**IEEE P802.11  
Wireless LANs**

**PLCP header structure proposal**

Subject: PCLP header structure proposal

**doc.: IEEE 802.11-99/078**

Figure 1 Proposed PLCP header structure

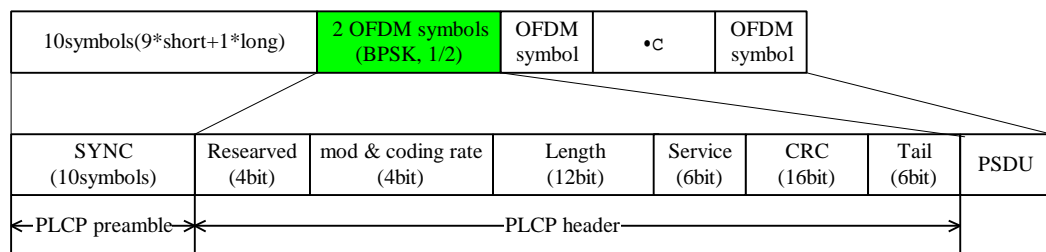
We felt that the one parity bit is not enough for reliability. We propose to use CRC16 instead of it. While the D3.0 PLCP header consists of one OFDM symbol and service field, we propose a new header structure that is composed by two OFDM symbols described in Fig.1.

This makes overhead lager. However we think it dose not make a big impact for throughput. We hope that IEEE802.11a will take this proposal into account for a discussion.

We assigned the following fields for the two OFDM symbols,

- 4bits for reserved,
- 4bits for mod & conding rate,
- 12bits for length,
- 6bits for service (maybe used for scrambler initialization),
- 16bits for CRC and
- 6bits for Tail.
